1 TEDD RED LINE #1 - UPGRADE
TO LED SIGNALS - 3/2008

STATE OF MARYLAND
DEPARTMENT OF TRANSPORTATION
STATE HIGHWAY ADMINISTRATION
OFFICE OF TRAFFIC & SAFETY
TRAFFIC ENGINEERING DESIGN DIVISION
US 13 BUSINESS (N. SALISBURY BOULEVARD)
AT NAYLOR STREET

SIGNALIZATION PLAN SHEET

TS NO. 1945 E DRAWING SG-01 OF 02 SHEET NO. 1 OF 2

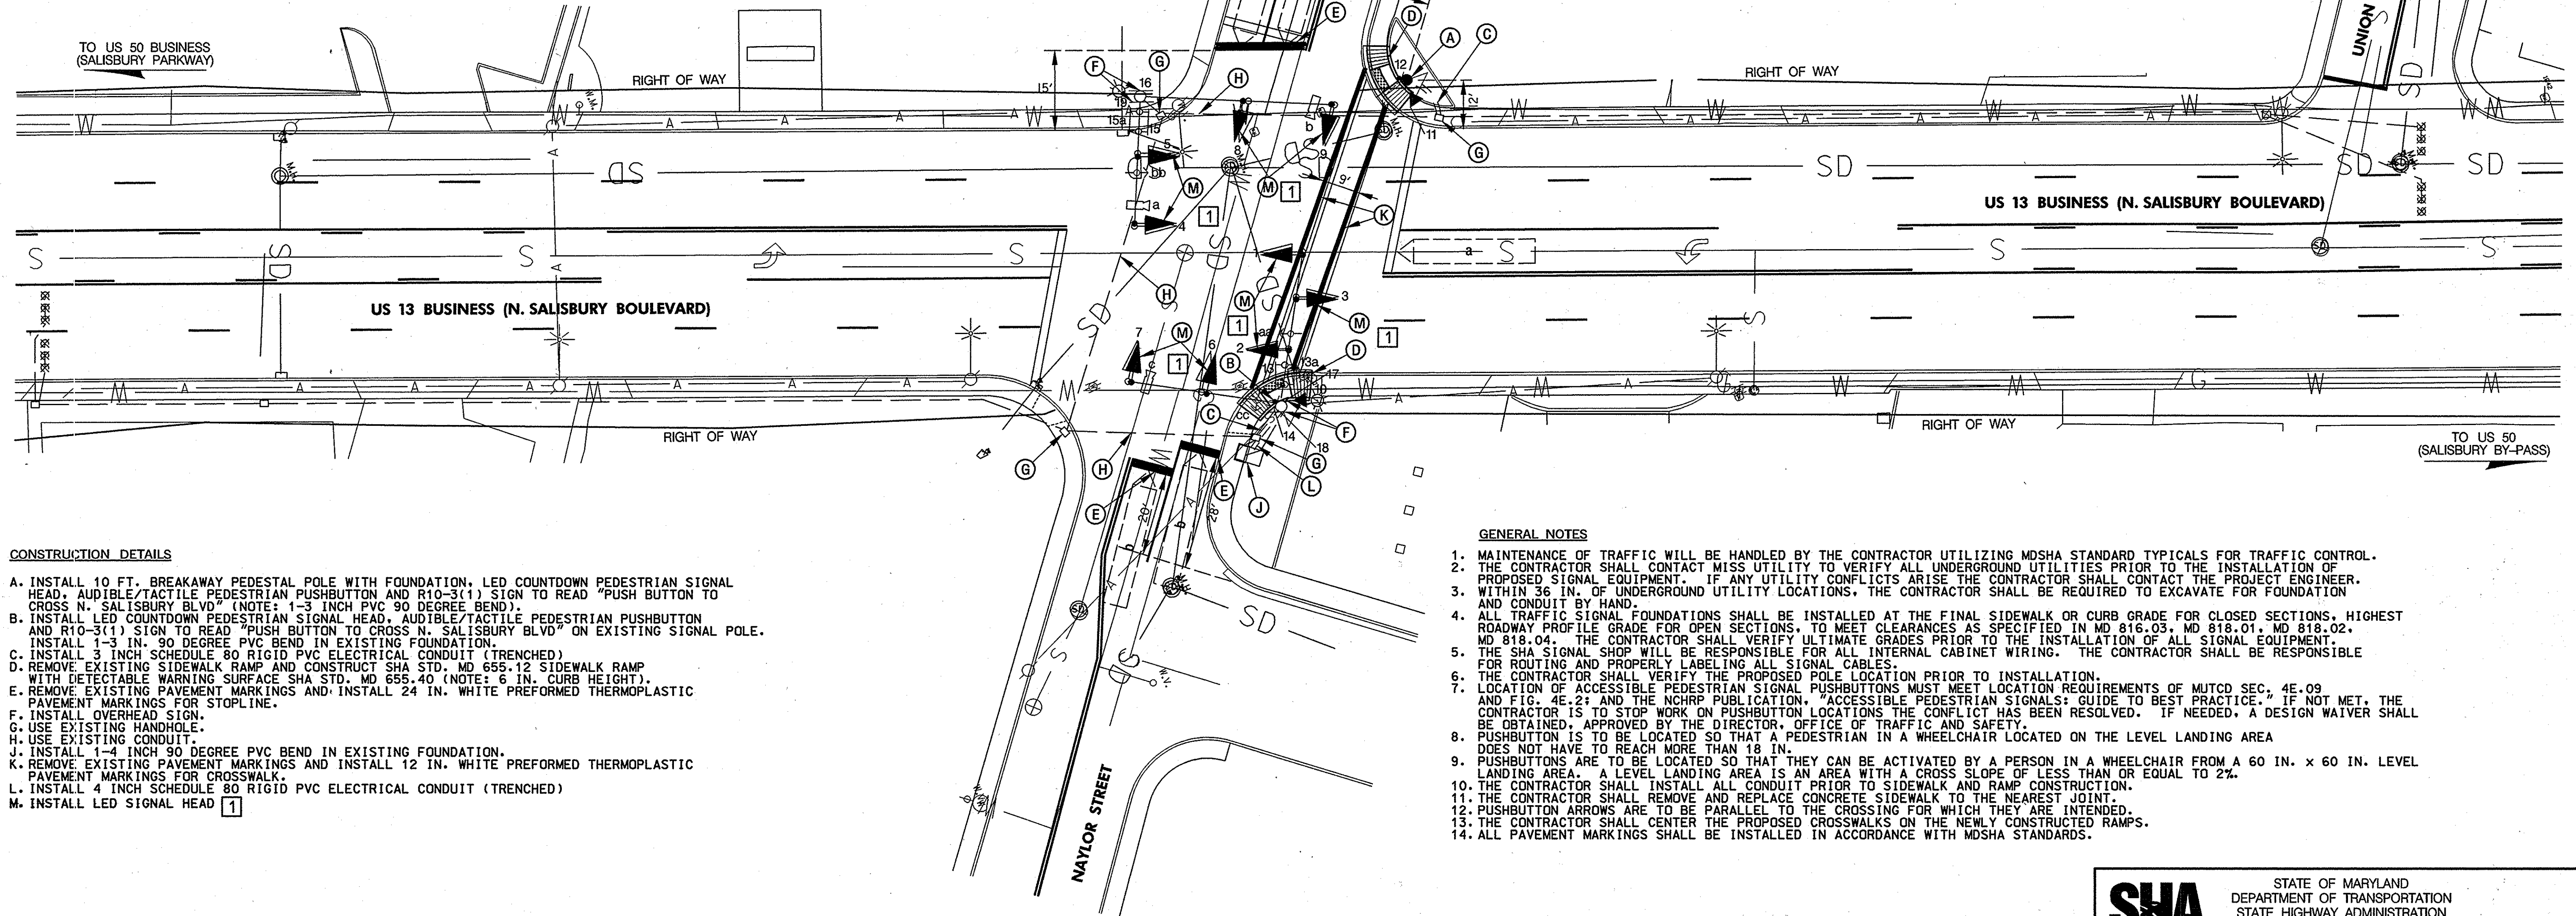
1 EXISTING SIGNALS
TO BE REMOVED

1 PROPOSED LED SIGNALS
